Access Compliance Report Public Rights-of-Way (Curb Ramps)

Intersection ID: 24079
 Main Street:
 LIVINGSTON_MILL_RD
 Cross Street:
 MOSS_RD
 Location:
 SW

ADA ID: A53C35523CBE
 Ramp Type:
 PerpDiag
 Initial Pass/Fail:
 Pass
 Overall Compliance:
 No
 Severity Score:
 10

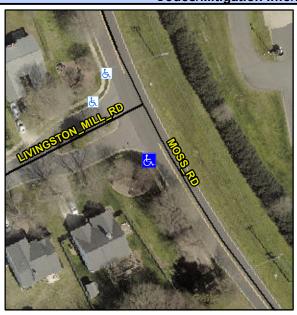
R304.2.1, R304.2.2-Perp, R304.3.2-Para, R304.5.3, R305.2

Remove & Replace Curb Ramp With Two New Directional Ramps or Equivalent.
